Access Compliance Report

Public Rights-of-Way

(Curb Ramps)

Intersection ID: 9490	Main Street: BARRINGTON_DR	Cross Street: CRAFTSBURY_DR	Location:	W
ADA ID: 8E13638E9798	Ramp Type: Perpendicular	Initial Pass/Fail: Fail	Overall Compliance: No	Severity Score: 1.25
Codes/Mitigation Info/Possible Solution		Field Measurements/Component Compliance

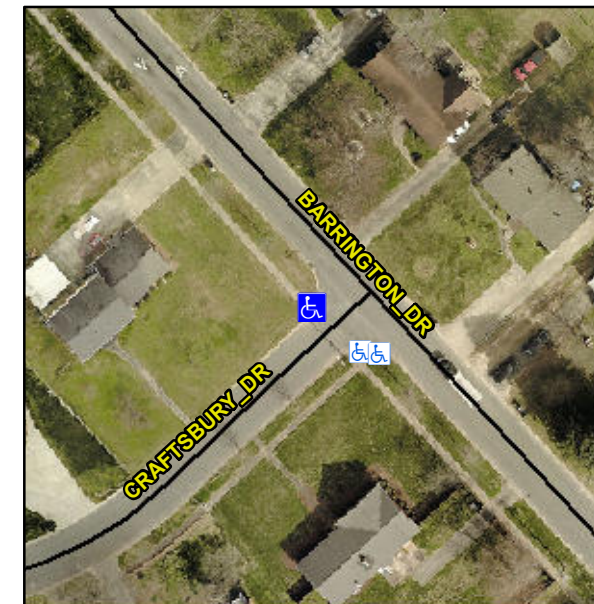
Not Found, R304.5.3

Compliance	Description	Data	Compliance	Description	Data
N/A	Ramp Length (in)	69.0	Yes	Ramp Slope (%)	5.5
Yes	Ramp Width (in)	48.0	No	Ramp XSlope (%)	2.3
N/A	Flare Type LT	N/A	N/A	Flare Type RT	N/A
N/A	Flare Slope LT (%)	N/A	N/A	Flare Slope RT (%)	N/A
N/A	Flare Traversable LT?	N/A	N/A	Flare Traversable RT?	N/A
N/A	Landing Length (in)	N/A	N/A	DWS Provided?	N/A
N/A	Landing Width (in)	N/A	N/A	DWS Contrast?	N/A
N/A	Landing Slope (%)	N/A	N/A	DWS Length (in)	N/A
N/A	Landing X Slope (%)	N/A	N/A	DWS Full Width?	N/A
N/A	Landing Curb? (Y/N)	N/A	N/A	DWS Offset (in)	N/A
N/A	Shared Landing?	N/A			
N/A	Gutter Ponding?	Yes	N/A	Gutter Slope (%)	N/A
N/A	Gutter Lip Ht (in)	0.5	N/A	Gutter X Slope (%)	N/A
N/A	Painted X Walk1?	No	N/A	Painted X Walk2?	N/A
	X Walk 1 Direction	To SE		X Walk 2 Direction	N/A
N/A	X Walk 1 Width (in)	N/A	N/A	X Walk 2 Width (in)	N/A
	X Walk 1 Slope (%)	4.1		X Walk 2 Slope (%)	N/A
	X Walk 1 X Slope (%)	0.1		X Walk 2 X Slope (%)	N/A

Remove & Replace Entire Ramp.
